MDS SELF-STORAGE

RE: Mesa Del Sol Self Storage 5500 Turing Dr. SE Grading and Drainage Plan Engineer's Stamp Date: 5/7/2025 Hydrology File: R16DA1004

Re: Mesa Del Sol Self Storage 2322 Mesa del Sol SE Traffic Circulation Layout

MESA DEL SOL ARCHITECTURAL CONTROL COMMITTEE SITE DEVELOPMENT PLAN REVIEW

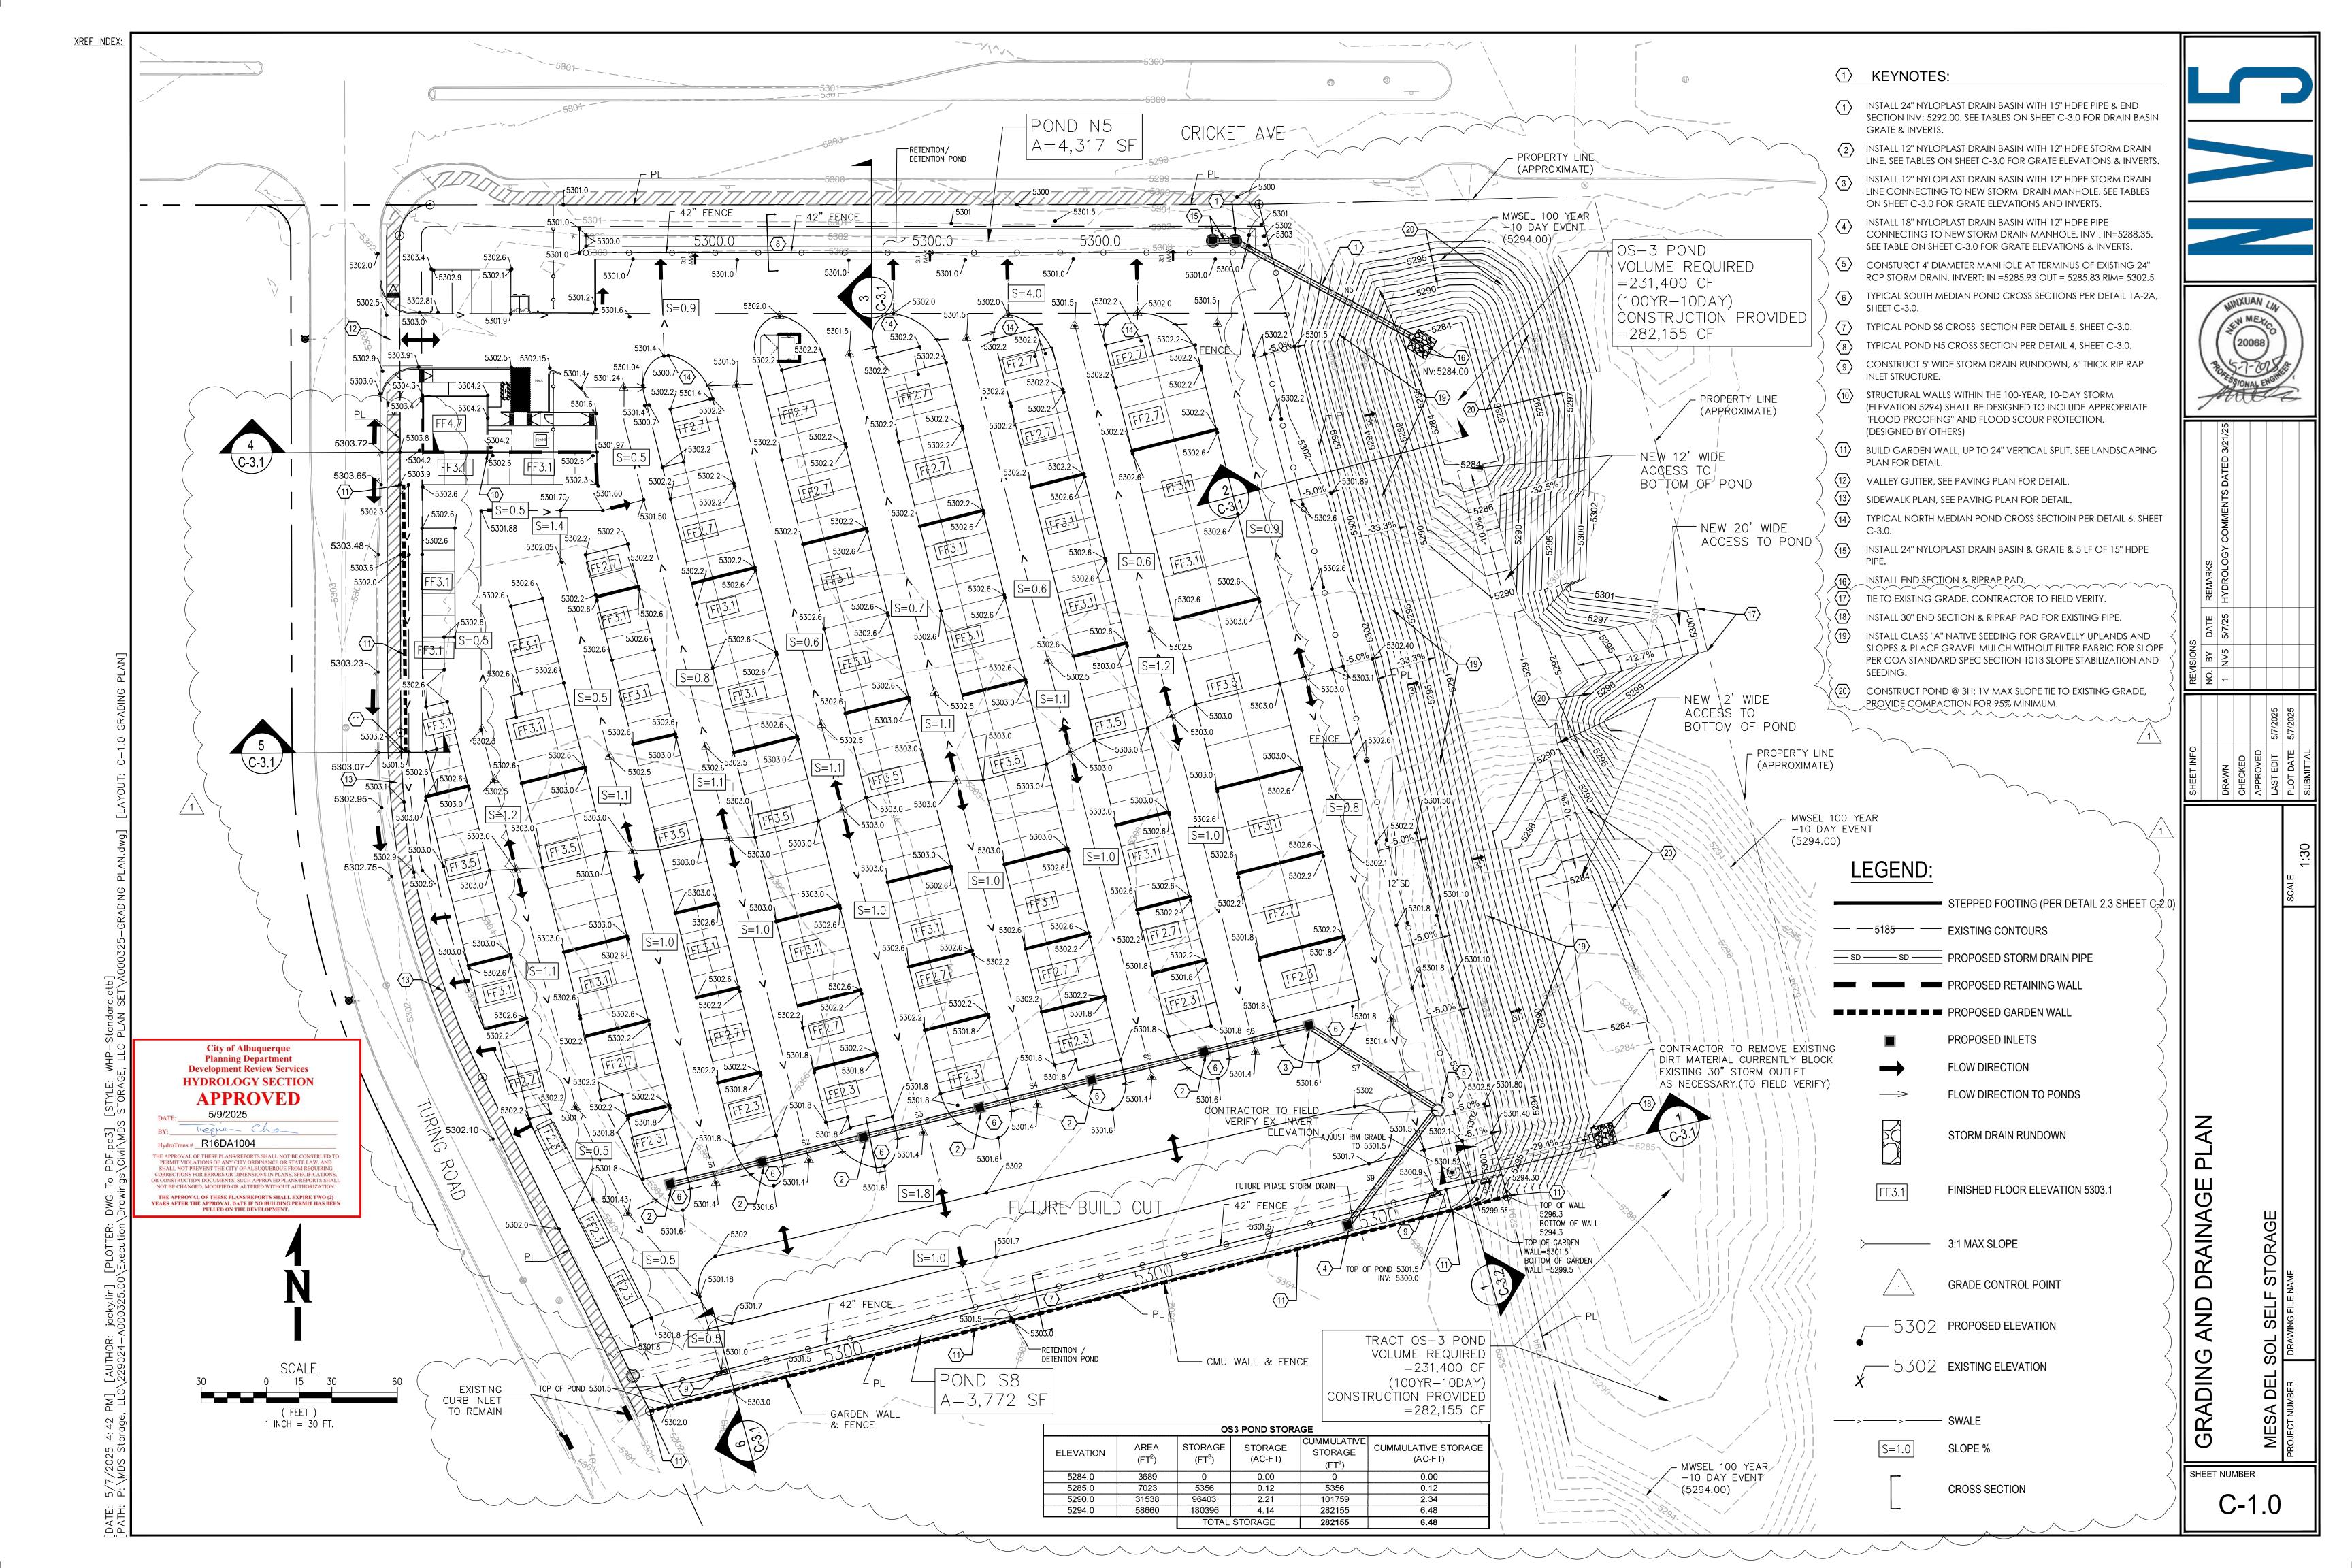
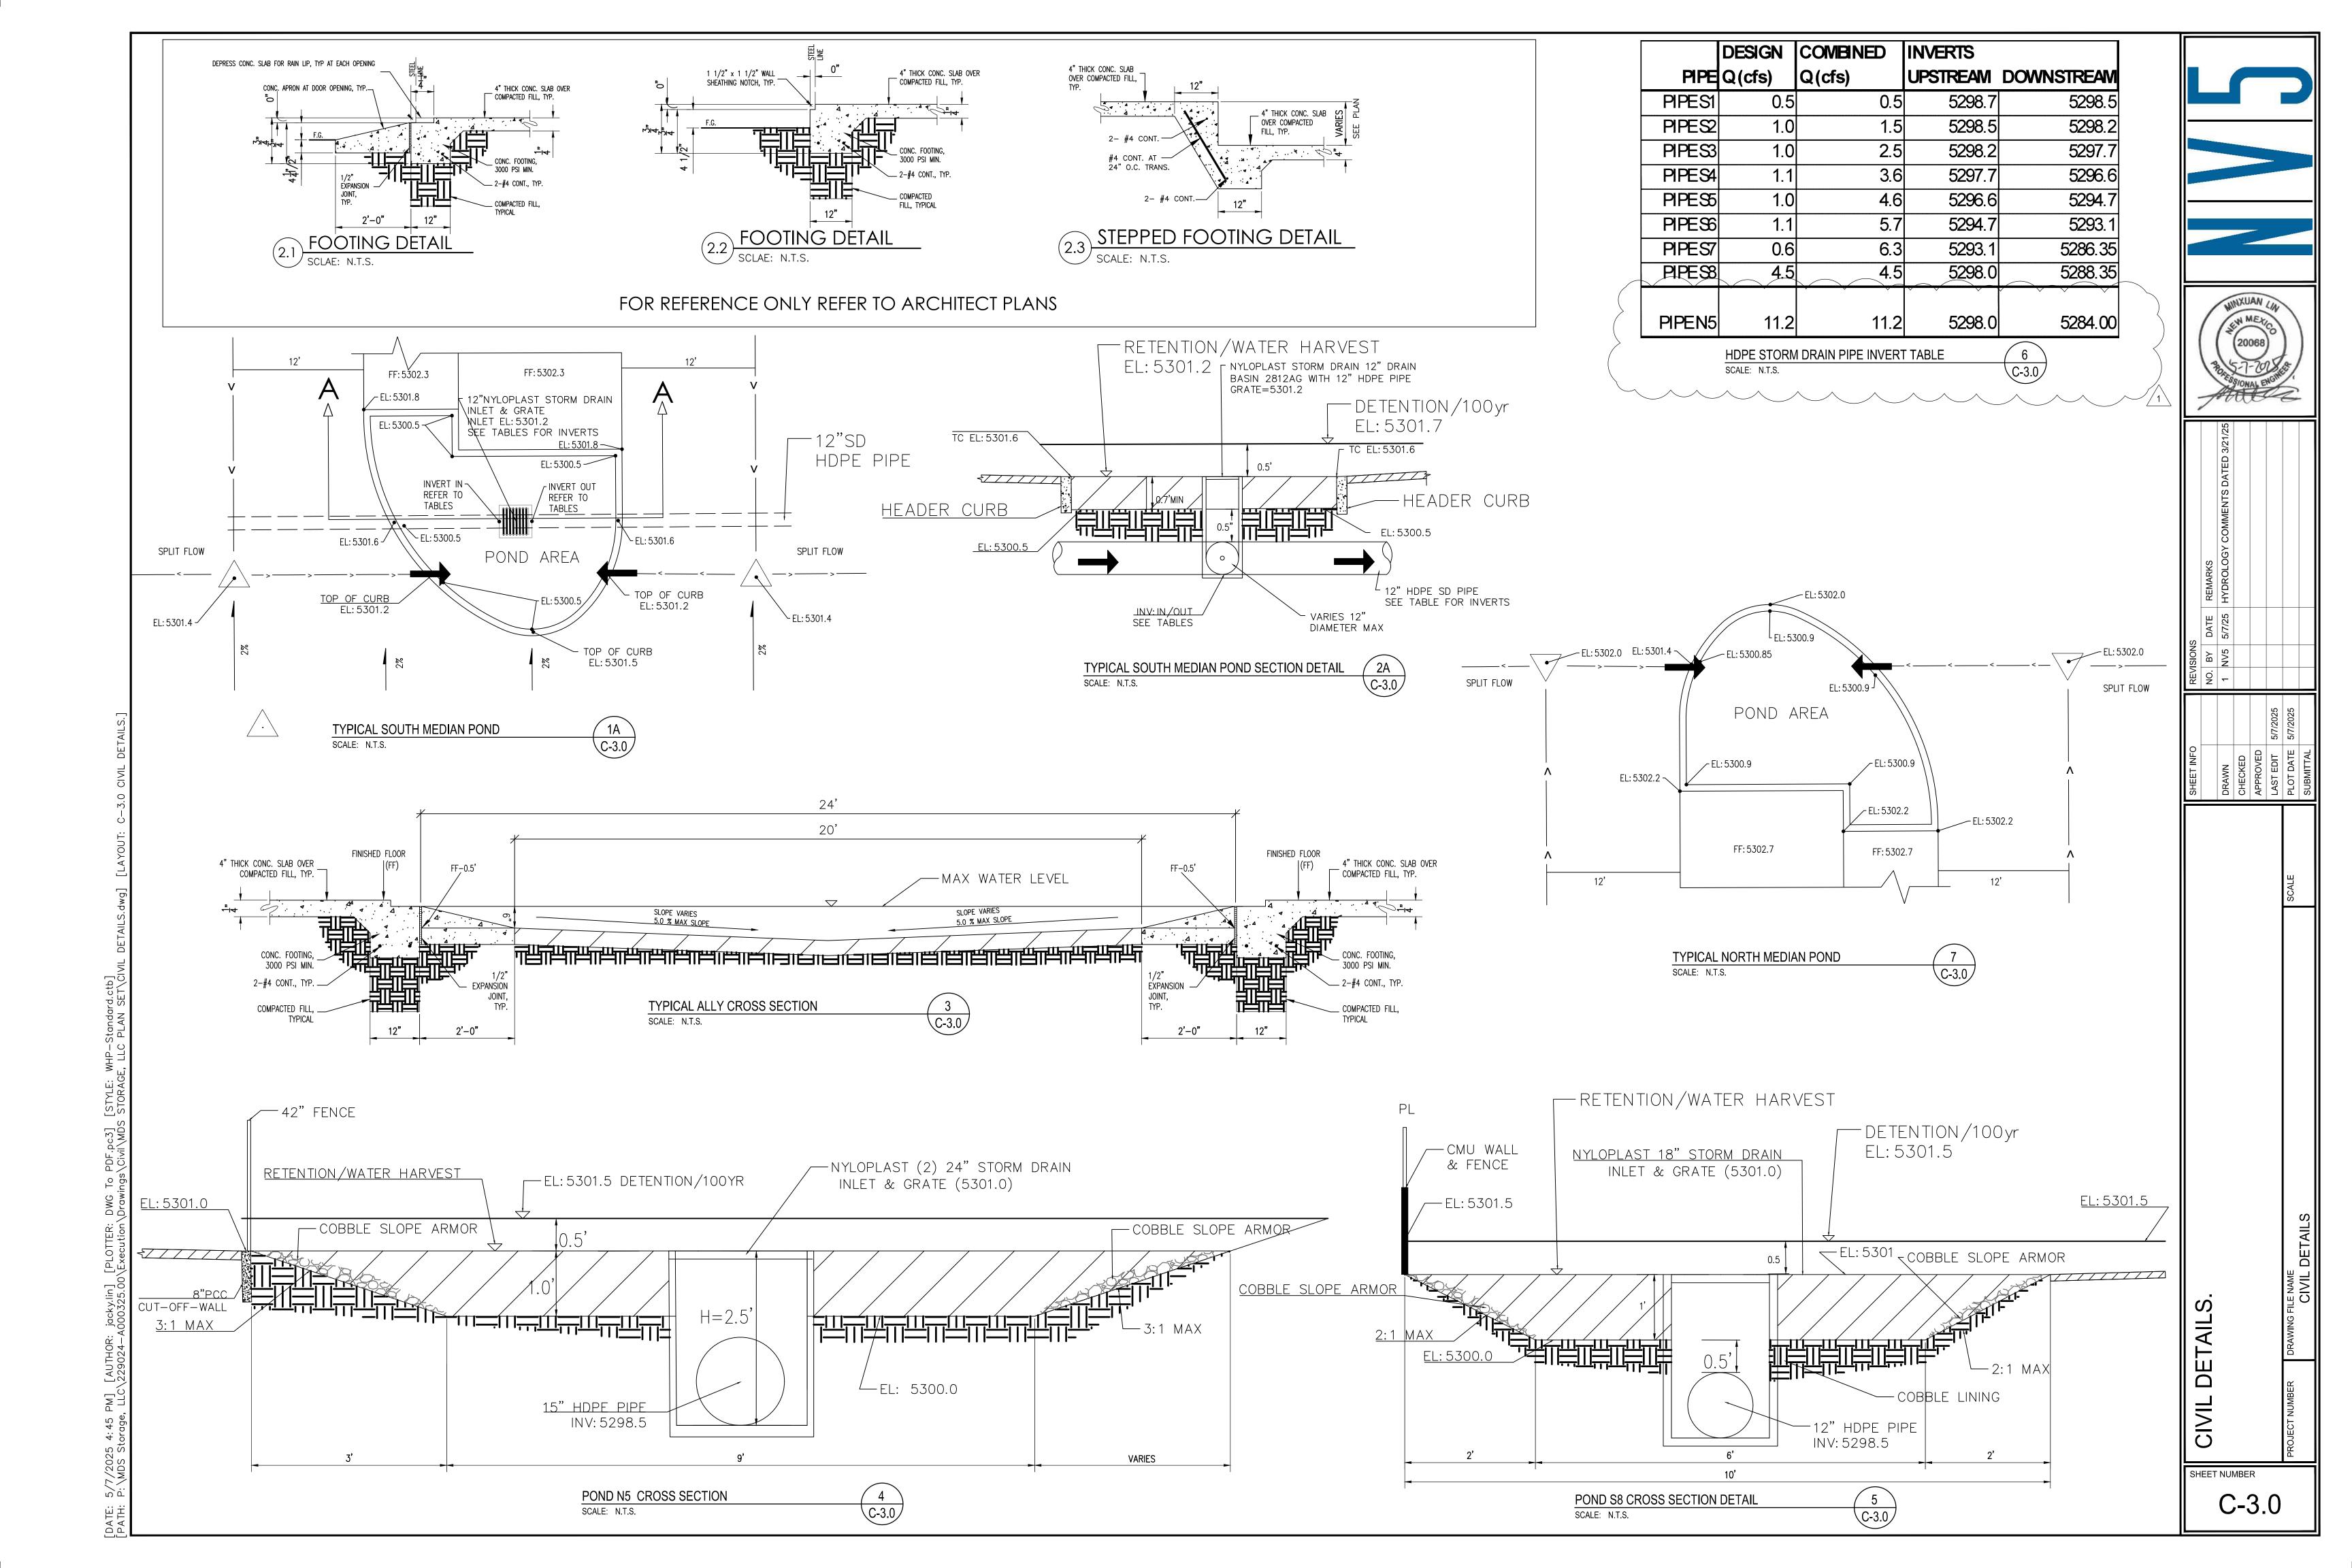
Based upon the information provided in your submittal received 5/7/2025, the Grading Plan is approved for Building Permit. Please attach a copy of this approved plan in the construction sets for Building Permit processing along with a copy of this letter.

1. Engineer's Certification, per the DPM Part 6-14 (F): *Engineer's Certification Checklist For Non-Subdivision* is required.

2. Please provide the executed paper Drainage Covenant (latest revision) printed on one-side only with Exhibit A and a check for \$25.00 made out to "Bernalillo County" for the stormwater quality pond per Article 6-15(C) of the DPM to Hydrology for review.
